1 Checks for Calculation No: NSTXU-CALC-11-28-00 #
Revision No: 00 #

Calculation of CSA tile Heat flux enhancement and fish scale angle

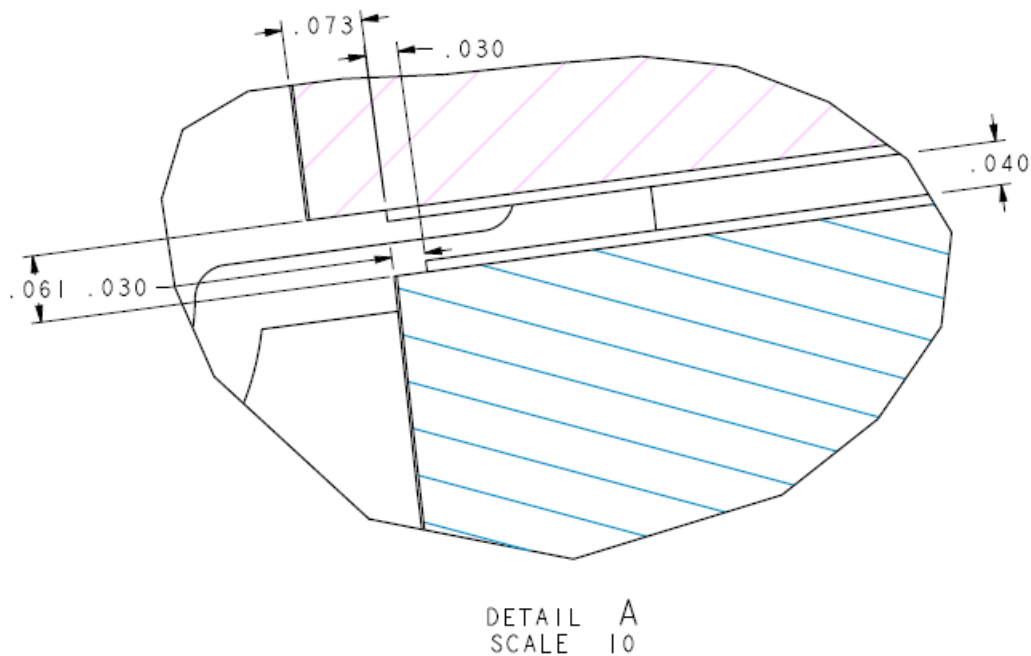
The enhancement factor is calculated as follows:

$$f_{enh} = \frac{\sin(\alpha + \beta)}{\sin(\alpha)}$$

The SRD table gives the minimum alpha as 7.3 degrees. At minimum alpha and maximum beta, the maximum enhancement factor is found to be 1.18 and the minimum is 1.13. This maximum enhancement factor would yield an effective surface heat flux of 6.14 MW/m^2 .

These values compare well to the values in the original calculation (1.18 @ 3.2" vs. 1.17 @ 3.3").

A discrepancy is found in the step height assumed between tiles. The original calculation reports 0.060" whereas the drawings indicate 0.073.

Lower Vertical Target Viewed from Above

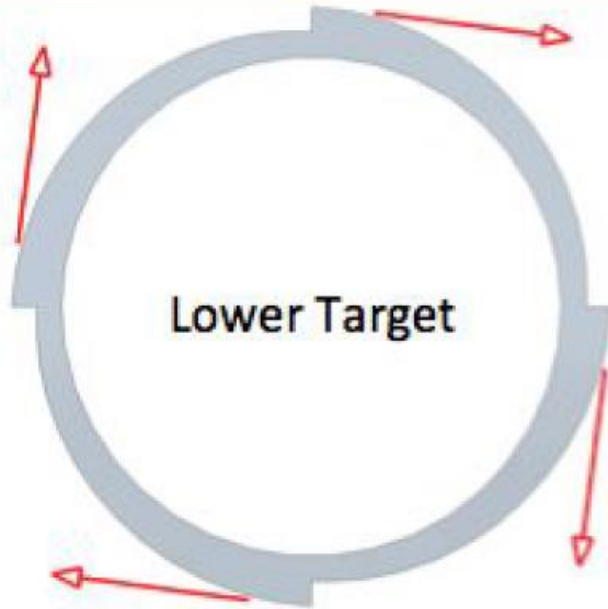
This image is taken from E-ED1459 at zone I-8 showing a section view from above looking downward at the HTP. Moving clockwise, there is a step outward in major radius.

This image is from NSTX-U-RQMT-SRD-003-02 giving the sense of the fish-scale steps. Moving clockwise, there is a step outward in major radius. This sense matches the current drawing.
